CHATHAM COUNTY PURCHASING DEPARTMENT
ADDENDUM NO. 3 TO ITB # 17-0074-4

FOR: MEMORIAL STADIUM

ADDENDUM NO. 3

CHANGES TO PROJECT DRAWINGS:

PS-1.1
SOUND SYSTEM
SHOP DRAWING

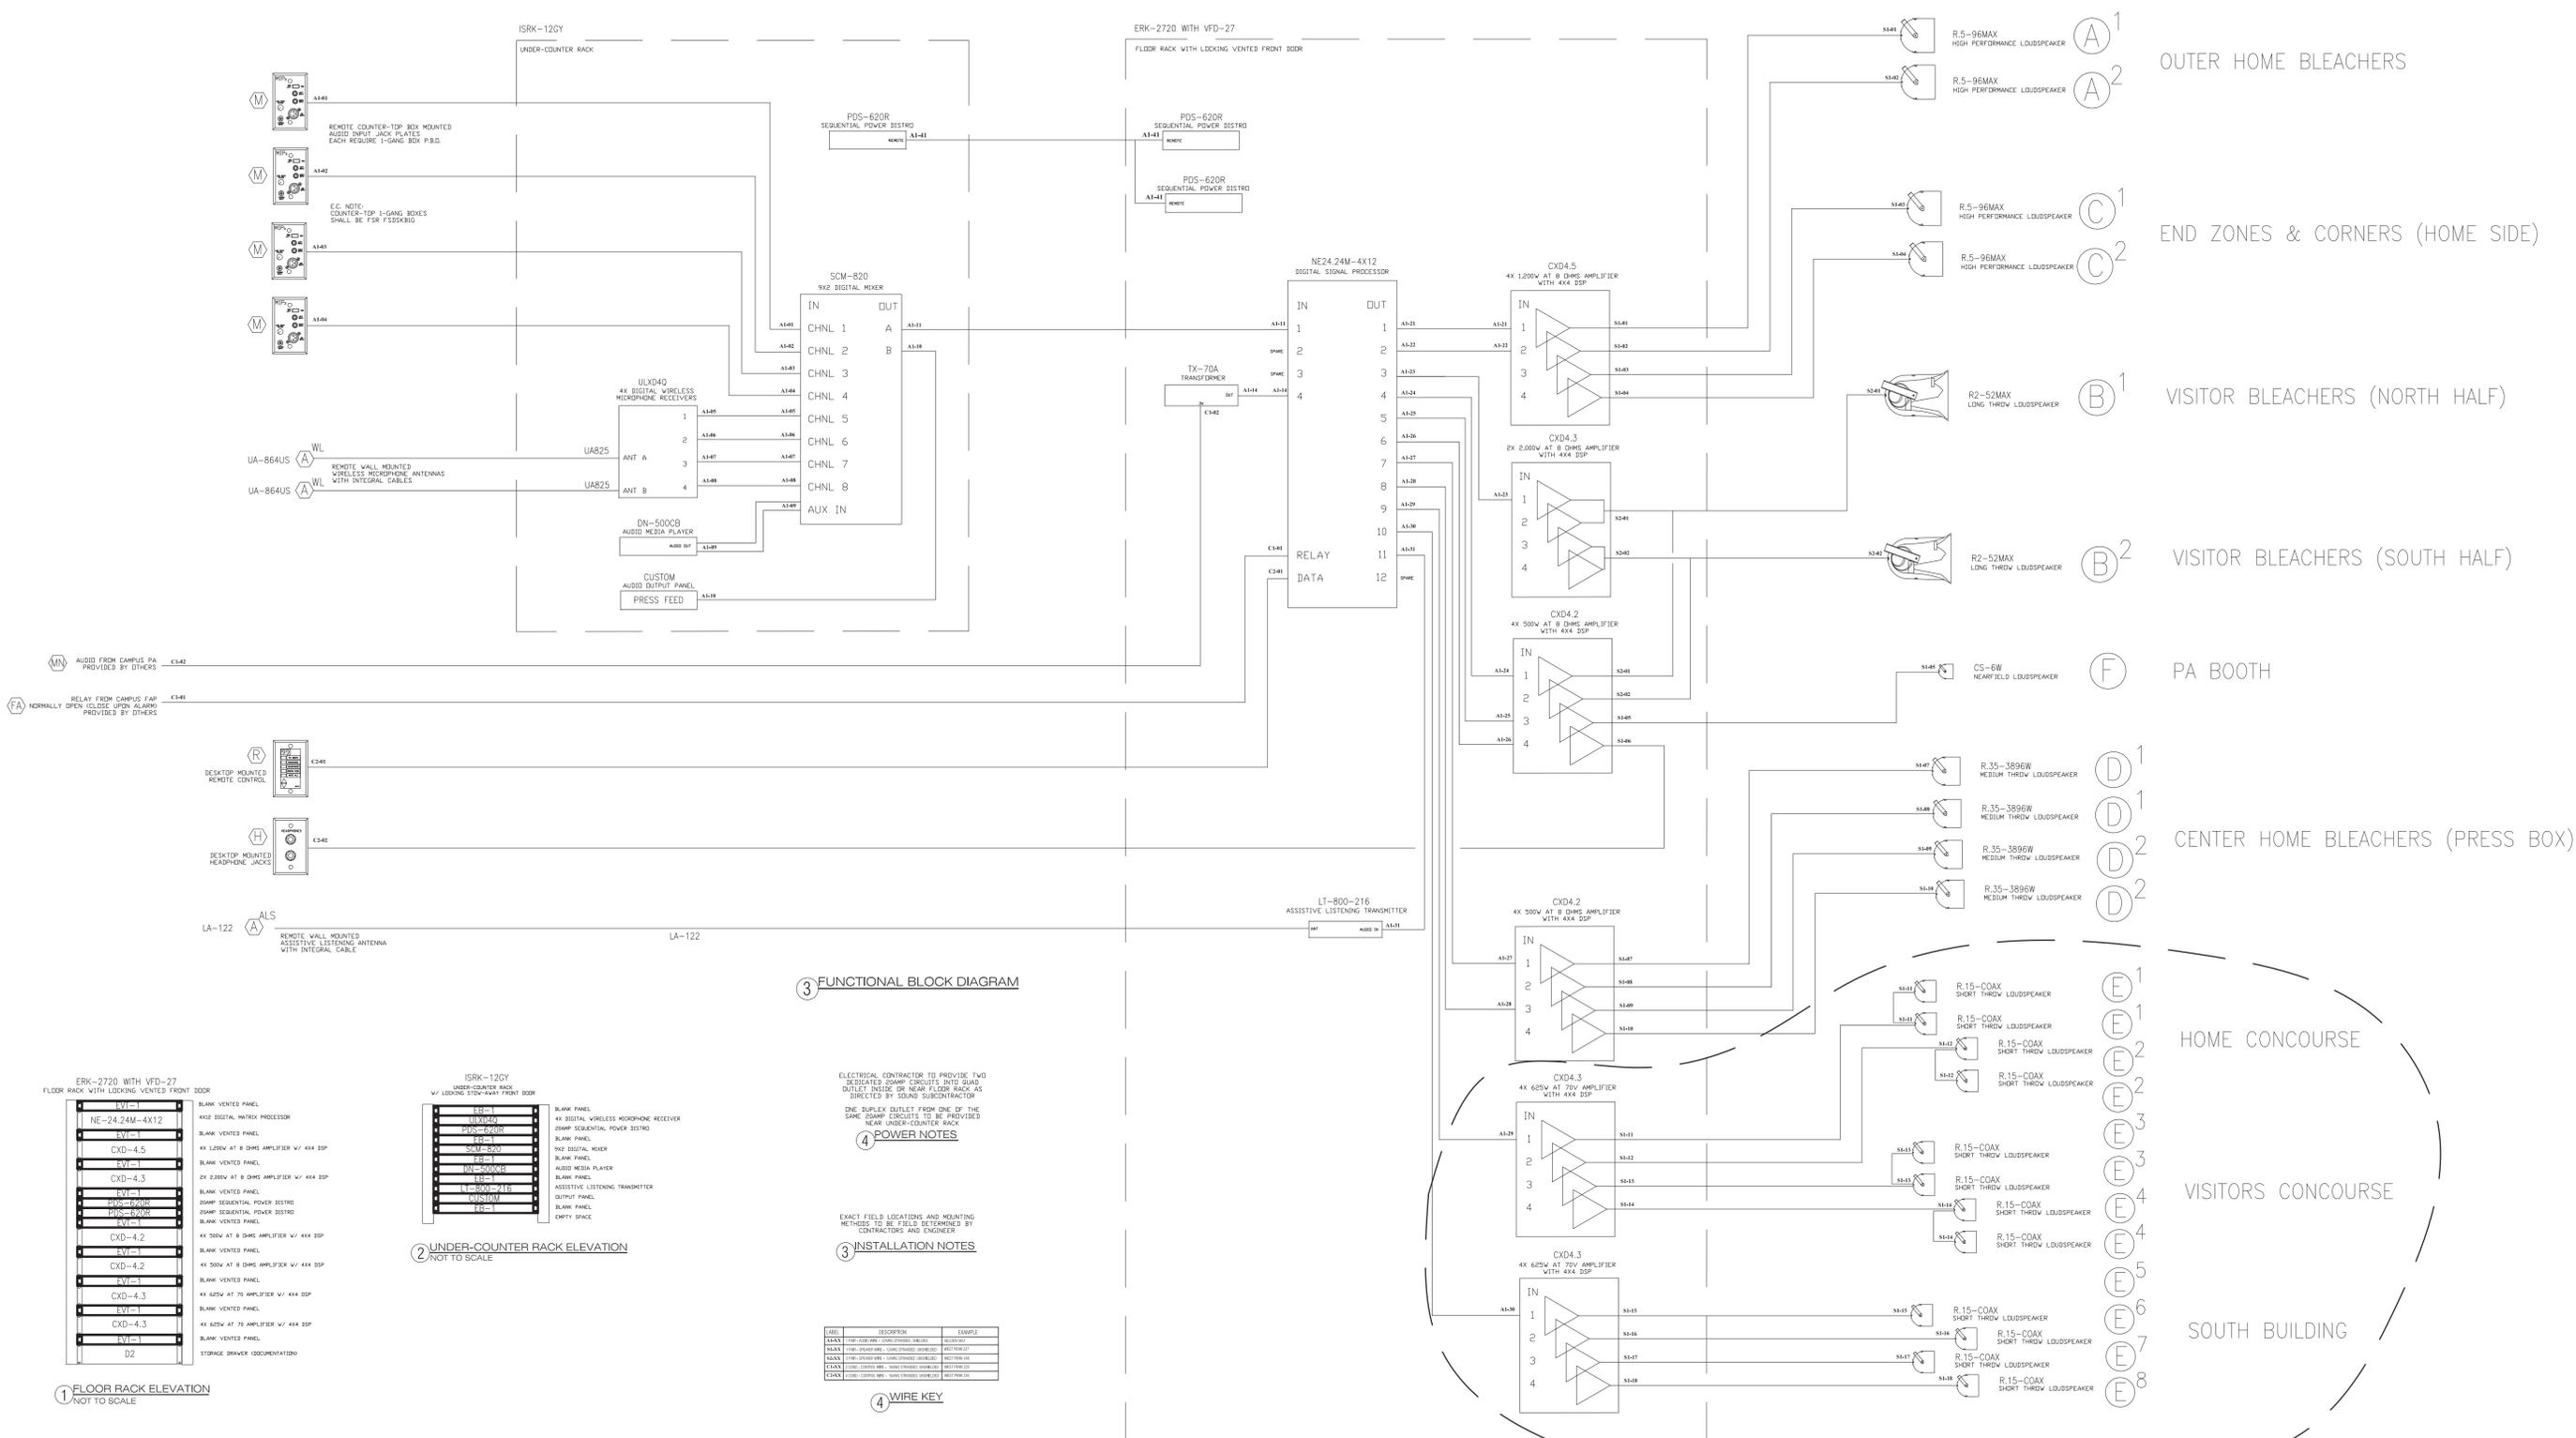
21. Question: We see on Sheet A-204, where (5) of the (11) speakers for the base bid are shown on the east elevation of the press box. Please advise on the location of the other (6) speakers. Also, alternate #7A in the spec calls for one more speaker to be added. This differs from the alternates listed on G001. Please advise if we are to price alternate #7A and #7B listed in spec section 116510.
Answer: Please see attached drawing PS-1.1 Functional Block Diagram for locations of base bid speakers identified in specification section 116510. Please provide as Alternate #8 a cost for twelve (12) additional speakers for the home and visitor concourse areas and the end zone (south) building as noted on PS-1.1 Functional Block Diagram (reference items #6 and #7 above in CHANGES TO PROJECT MANUAL).

25. Question: Do you have plans to attach any speakers to sports lighting poles? Speakers are shown, but doesn't show what they are mounted to.
Answer: Yes. The Outer Home Bleacher speakers and the Visitor Bleacher speakers identified in the attached PS-1.1 Functional Block Diagram will be attached to the sports lighting poles.

The Alternate #8 bid installation is to include TWELVE additional loudspeakers and associated electronics and mounting hardware for the concourse areas and end zone (south) building. The speakers will be mounted per plans and in coordination with the Sound System Contractor, Electrical Engineer and Owner. The speaker wiring will be provided as EIGHT home runs as shown on PS-1.1 Functional Block Diagram and wire key. All wiring is to be protected per the NEC.
